**Omaha Public Power District**  
1623 Harney Omaha, Nebraska 68102-2247  
402/536-4000

July 5, 1988  
LIC-88-537

SUBJECT: Inspection Report 88-15 - June 8, 1988 Enforcement Conference

On June 8, 1988, OPPD met with members of the NRC to discuss the details of an NRC inspection as documented in report 50-285/88-15. In Attachment 1 are copies of the overheads used during the June 8, 1988 presentations. In Attachment 2 are responses to questions that were raised during the conference.

SIRWT LEVEL INSTRUMENTATION SCHEMATIC  
(TYPICAL FOR FOUR CHANNELS)

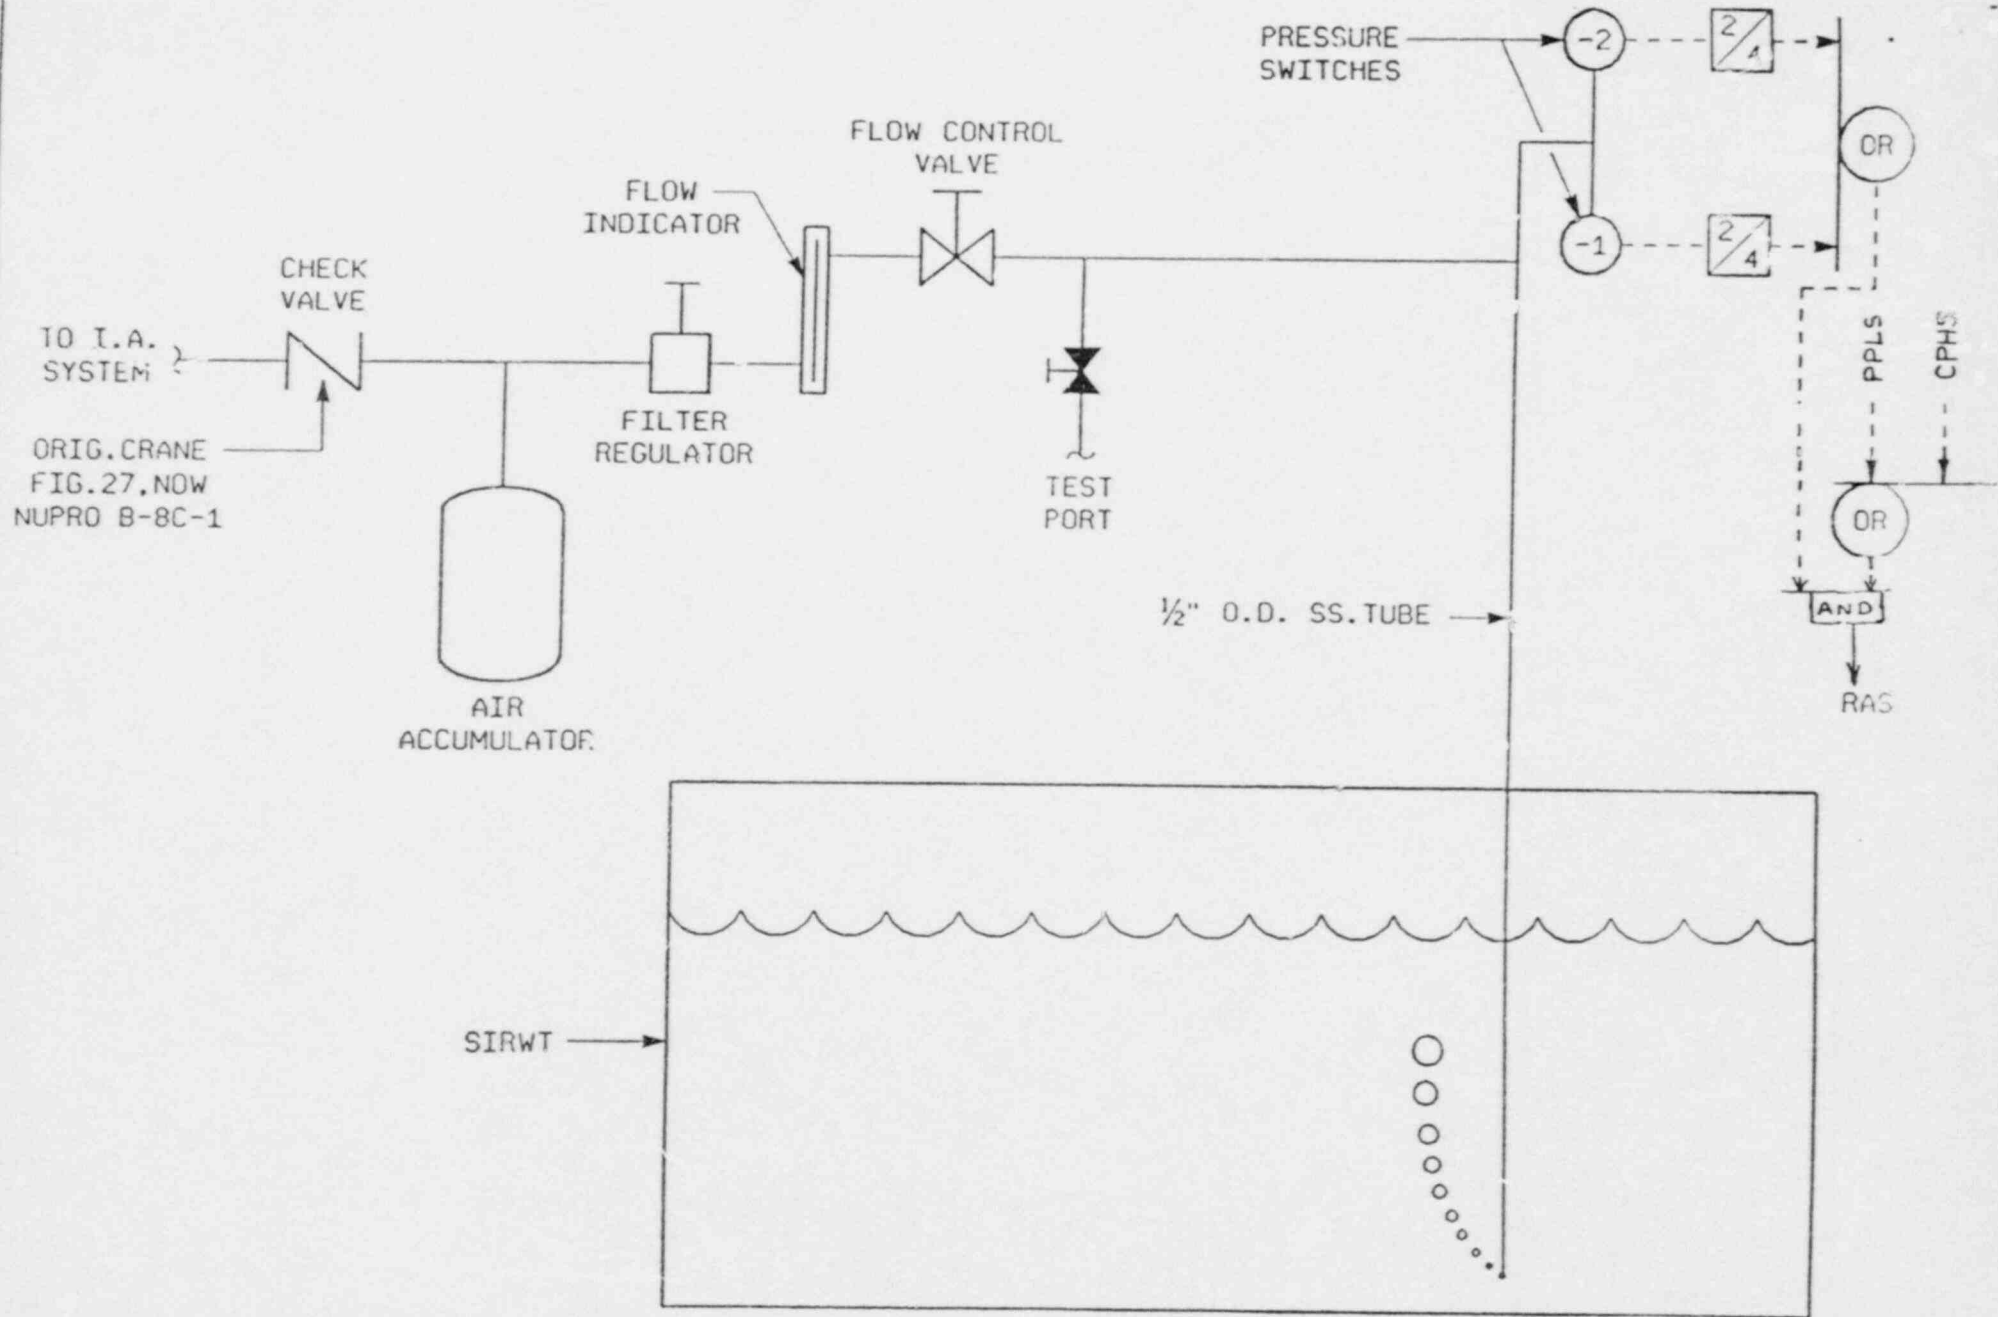
- PROBLEM REPORTED TO NRC (LER DATED 5/16/88)

- DESIGN BASIS

- USAR DESIGN BASIS

- REVISED DESIGN BASIS

- SYSTEM CONFIGURATION

- REPLACEMENT OF CRANE FIG #27 CHECK VALVES WITH NEW LEAK TIGHT (NUPRO B-8C-1) CHECK VALVES.
- NEW VALVES INCLUDED IN THE ISI PROGRAM
- INSTALLATION IS PROPOSED TO BE FURTHER MODIFIED TO FACILITATE FUNCTIONAL TESTING (MR-FC-88-39)
- REVIEW OF OTHER ACCUMULATOR INSTALLATIONS

Suction Side of Safety Injection System

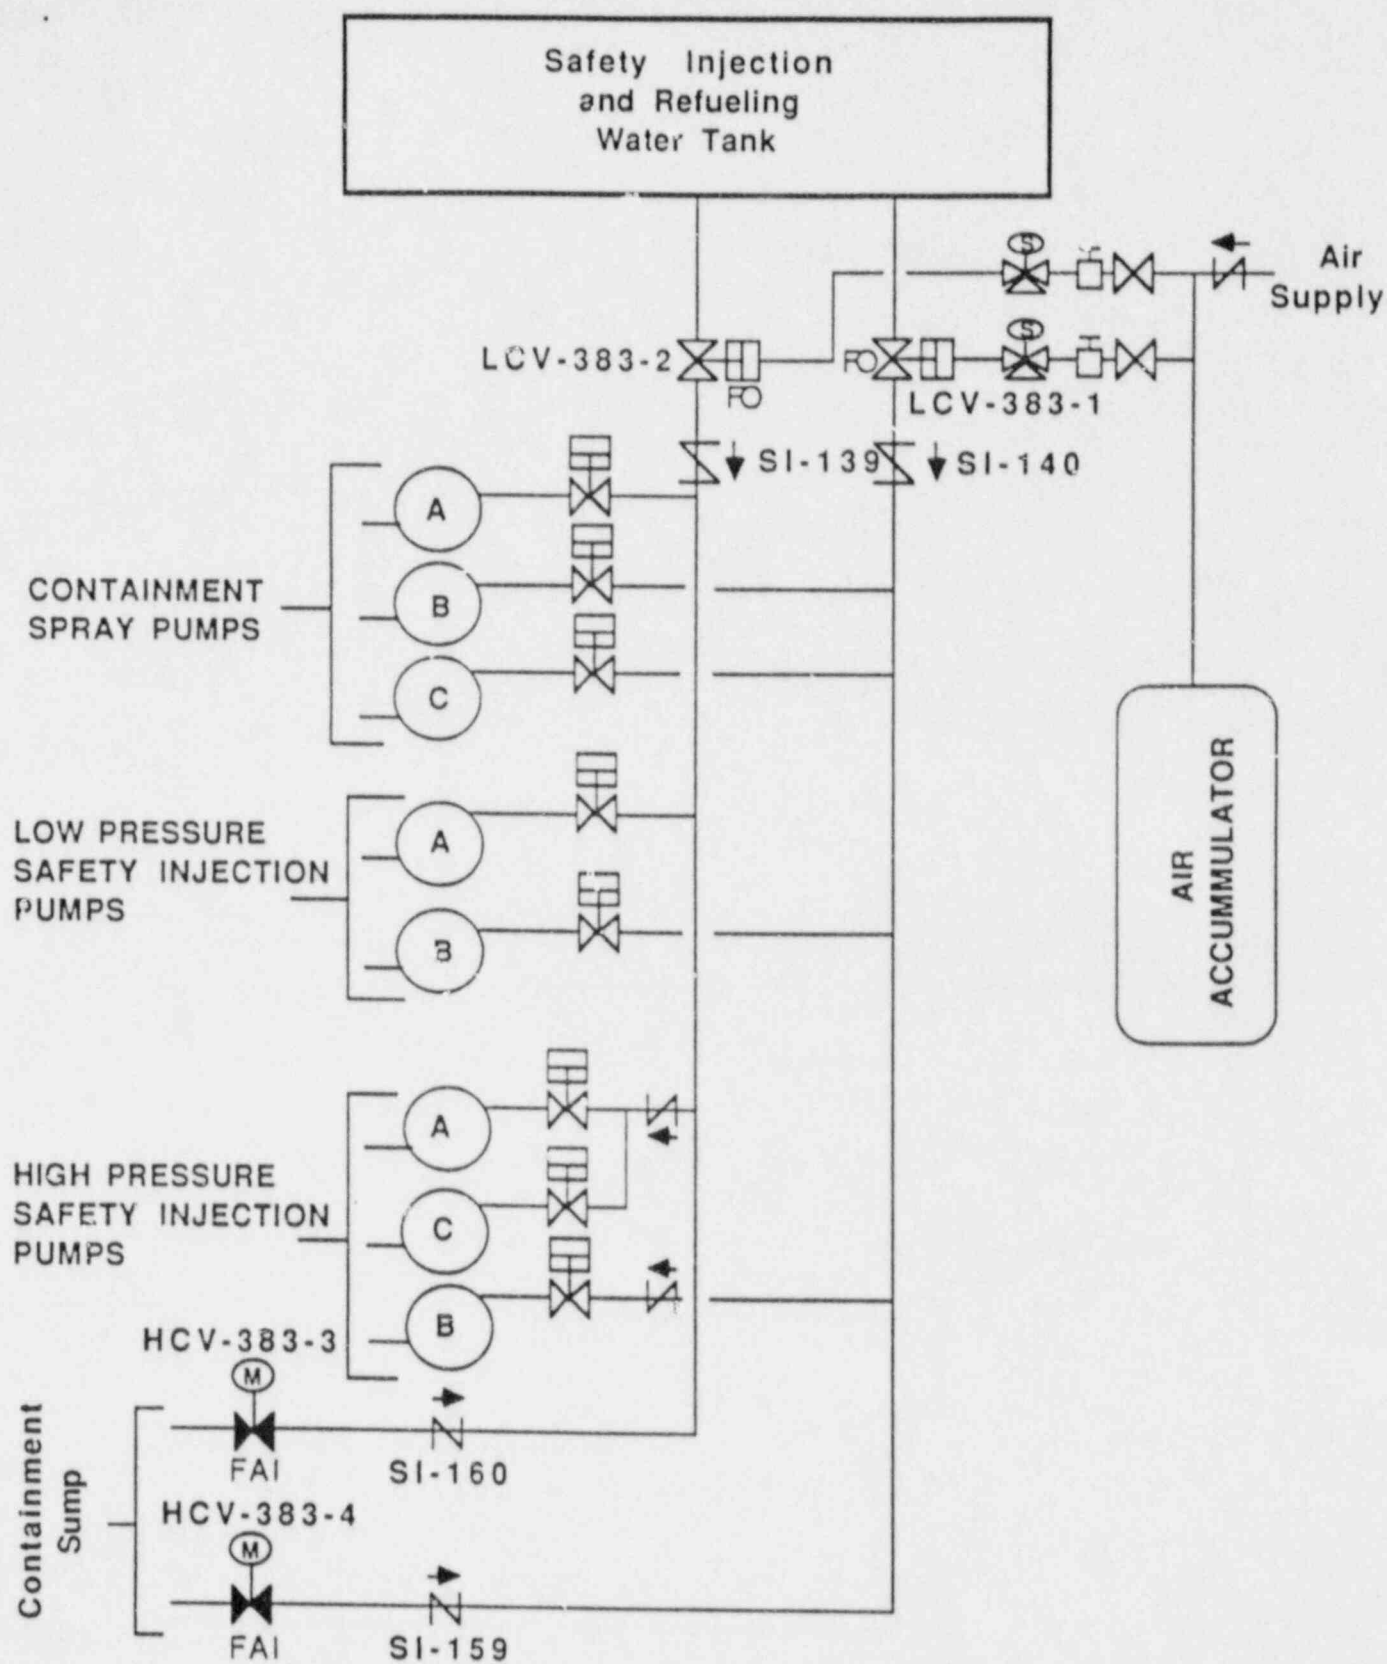
OPEN ITEM 285/8815-06: LCV-383-1 & 2 - ONLY ONE ACCUMULATOR IS PROVIDED FOR TWO VALVES. THIS DOES NOT MEET SINGLE FAILURE CRITERIA.

- LCV-383-1 AND LCV-383-2 ARE NORMALLY OPEN, FAIL OPEN AIR OPERATED VALVES THAT MUST BE OPEN TO PROVIDE A BORATED WATER SOURCE FOR THE SAFETY INJECTION AND CONTAINMENT SPRAY PUMPS EARLY IN A DESIGN BASIS LOCA. ONCE LEVEL IN THE SAFETY INJECTION REFUELING WATER TANK (SIRWT) REACHES 16" LEVEL, THE VALVES RECEIVE A RECIRCULATION ACTUATION SYSTEM (RAS) SIGNAL TO CLOSE. THE VALVES ARE CLOSED TO PREVENT BACKFLOW OF ACTIVATED COOLANT FROM THE CONTAINMENT FLOOR FROM ENTERING THE SIRWT.

- LCV-383-1 AND LCV-383-2 RELY ON ONE AIR ACCUMULATOR TO CLOSE WITH LOSS OF INSTRUMENT AIR TO PERFORM THE RAS FUNCTION. THE TWO VALVES HAVE THEIR INDEPENDENT SOLENOID VALVES DOWNSTREAM OF THE ACCUMULATOR AND ITS ASSOCIATED CHECK VALVE. THERE IS NO SINGLE FAILURE OF THE ACCUMULATOR OR CHECK VALVE, ACTIVE OR PASSIVE, THAT WOULD PREVENT THE VALVES FROM GOING TO THEIR FAILED POSITION. PASSIVE FAILURE OF THE ACCUMULATOR AND ASSOCIATED TUBING OR AN ACTIVE FAILURE OF THE CHECK VALVE COULD PREVENT BOTH VALVES FROM BEING CLOSED.

- AN ADDITIONAL SINGLE FAILURE OF ONE OF THE CHECK VALVES, SI-140 OR SI-139, WOULD HAVE TO OCCUR BEFORE THE SAFETY FUNCTION (I.E., PREVENTING BACKFLOW) IS INHIBITED.

- LCV-383-1 AND LCV-383-2 ARE IN PARALLEL. THIS DESIGN ARRANGEMENT ENSURES THAT WITH ANY SINGLE FAILURE, AT LEAST ONE PATH OF FLOW FROM THE SIRWT TO THE SI/CS PUMPS WOULD BE AVAILABLE. ALSO, SINCE THE VALVES ARE IN PARALLEL, ONE VALVE FAILING TO CLOSE OR BOTH VALVES FAILING TO CLOSE ON RAS, WOULD HAVE THE SAME EFFECT ON THEIR ABILITY TO PERFORM THEIR SECONDARY SAFETY FUNCTION, THUS, CHECK VALVES SI-139 AND SI-140 ARE REQUIRED TO MEET SINGLE FAILURE CRITERIA FOR PREVENTING BACKFLOW.

THE FACT THAT LCV-383-1 AND LCV-383-2 SHARE AN ACCUMULATOR DOES NOT CONSTITUTE A VIOLATION OF PORT CALHOUN STATION'S OR CURRENT NRC SINGLE FAILURE CRITERIA.
